**+MEMORANDUM**

**TO:** Historic Preservation Board  
**FROM:** Merrilyn C. Rathbun, Fort Lauderdale Historical Society  
**SUBJECT:** Agenda for December 1, 2014  
**DATE:** Nov. 24, 2014

<b>Case</b>	H14014	<b>FMSF #</b>	
<b>Applicant</b>	<i>Hansen Associates Architecture &amp; Design</i>		
<b>Owner</b>	Michelle Grosman		
<b>Address</b>	1016 Waverly Road		
<b>General Location</b>	Approximately 117 feet east of the SW 11 <sup>th</sup> Avenue and Waverly Road intersection.		
<b>Legal Description</b>	LOTS 1,2,3,4,5,6 AND THE EAST HALF OF LOT 7 BLOCK 101 "WAVERLY PLACE" PLAT BOOK 2 PAGE 19 OF MIAMI-DADE COUNTY, LOCATED IN BWD COUNTY, FL, LESS AND EXCLUDING THE WEST 5 FEET OF THE EAST ON-HALF OF LOT 7, BLOCK 101 OF WAVERLY PLACE.		
<b>Existing Use</b>	Residence		
<b>Proposed Use</b>	N/A		
<b>Applicable ULDR Sections</b>	47-24.11.C.3.c.i, 47-24.11.C.4.c		
<b>Request(s)</b>	Certificate of Appropriateness for Demolition 1. Demolition of an existing single-family residence.

Figure 1. From the applicant's plan.

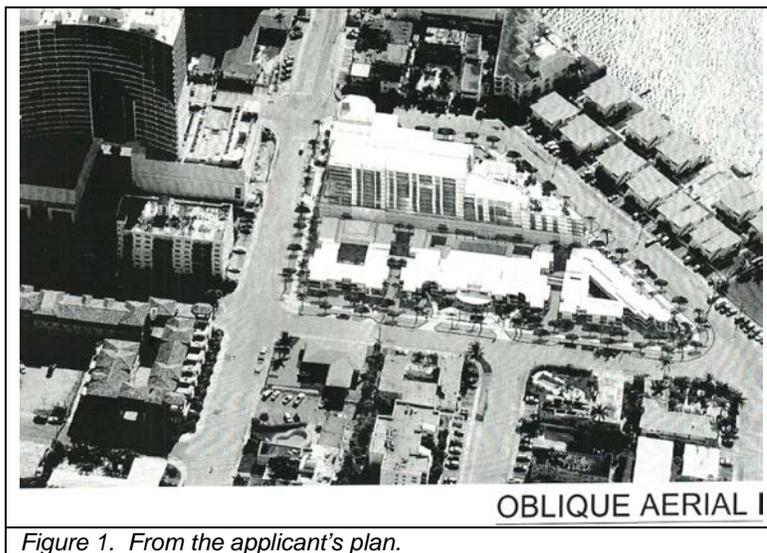
ULDR Section 47-24.11.C.3.c.i	Consultant Response
a) <i>The effect of the proposed work on the landmark or the property upon which such work is to be done;</i>	CONSULTANT RESPONSE The only change, visible from the exterior to the historic hotel complex is the addition of the canopy to the entrance. The design of the canopy has been modified to lessen its impact on the historic structure. The increased mass of the condo building will have a greater shadow impact on the historic resource

b) <i>The relationship between such work and other structures on the landmark site or other property in the historic district;</i>	CONSULTANT RESPONSE The proposed condo building is sited very close to the historic hotel building and could have some adverse visual impact on the resource.

e) <i>Whether the plans may be reasonably carried out by the applicant;</i>	CONSULTANT RESPONSE n/a
f) <i>Whether the plans comply with the "United States Secretary of the Interior's Standards for Rehabilitation and Guidelines for Rehabilitating Historic Buildings."</i>	CONSULTANT RESPONSE The historic buildings are two stories in height, the new construction is considerably larger in height and mass. See below

The related new construction is differentiated from the old, but it is much larger in terms of massing size and scale.

<b>ULDR Section 47-24.11.C.3.c.iii</b>	<b>Consultant Response</b>
a) <i>The height of the proposed building shall be visually compatible with adjacent buildings.</i>	CONSULTANT RESPONSE The height of the proposed new construction is significantly higher than that of the historic resource

b) <i>The relationship of the width of the building to the height of the front elevation shall be visually compatible to buildings and places to which it is visually related.</i>	CONSULTANT RESPONSE The width and height of the new construction differs from the historic structure but is similar to that of other high rise buildings in the neighborhood

i) <i>The size of a building, the mass of a building in relation to open spaces, the windows, door openings, porches and balconies shall be visually compatible with the buildings and places to which it is visually related.</i>	CONSULTANT RESPONSE The proposed new construction is compatible with other large scale buildings in the immediate vicinity. The neighborhood is a mixture of mainly low rise buildings interspersed with high rise construction.

Figure 1. From the applicant's plan.

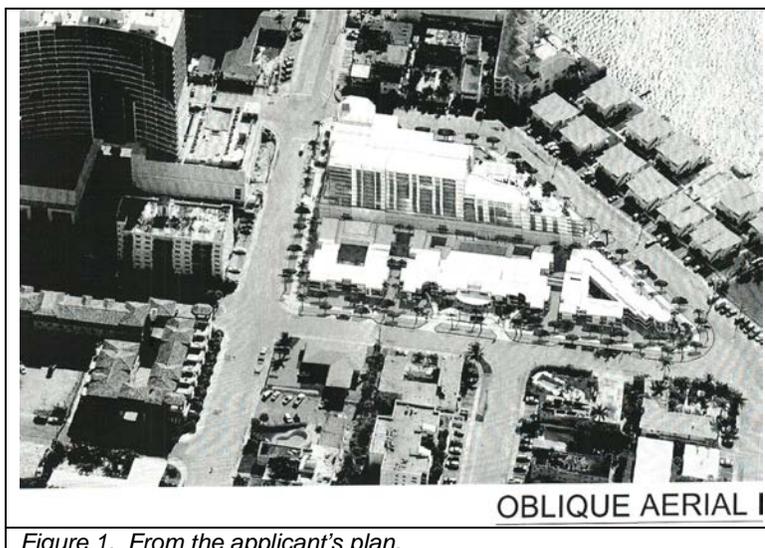
ULDR Section 47-24.11.C.3.c.i	Consultant Response
a) <i>The effect of the proposed work on the landmark or the property upon which such work is to be done;</i>	CONSULTANT RESPONSE The only change, visible from the exterior to the historic hotel complex is the addition of the canopy to the entrance. The design of the canopy has been modified to lessen its impact on the historic structure. The increased mass of the condo building will have a greater shadow impact on the historic resource

b) <i>The relationship between such work and other structures on the landmark site or other property in the historic district;</i>	CONSULTANT RESPONSE The proposed condo building is sited very close to the historic hotel building and could have some adverse visual impact on the resource.

e) <i>Whether the plans may be reasonably carried out by the applicant;</i>	CONSULTANT RESPONSE n/a
f) <i>Whether the plans comply with the "United States Secretary of the Interior's Standards for Rehabilitation and Guidelines for Rehabilitating Historic Buildings."</i>	CONSULTANT RESPONSE The historic buildings are two stories in height, the new construction is considerably larger in height and mass. See below

<b>ULDR Section 47-24.11.C.3.c.iii</b>	<b>Consultant Response</b>
a) <i>The height of the proposed building shall be visually compatible with adjacent buildings.</i>	CONSULTANT RESPONSE The height of the proposed new construction is significantly higher than that of the historic resource

b) <i>The relationship of the width of the building to the height of the front elevation shall be visually compatible to buildings and places to which it is visually related.</i>	CONSULTANT RESPONSE The width and height of the new construction differs from the historic structure but is similar to that of other high rise buildings in the neighborhood

i) <i>The size of a building, the mass of a building in relation to open spaces, the windows, door openings, porches and balconies shall be visually compatible with the buildings and places to which it is visually related.</i>	CONSULTANT RESPONSE The proposed new construction is compatible with other large scale buildings in the immediate vicinity. The neighborhood is a mixture of mainly low rise buildings interspersed with high rise construction.
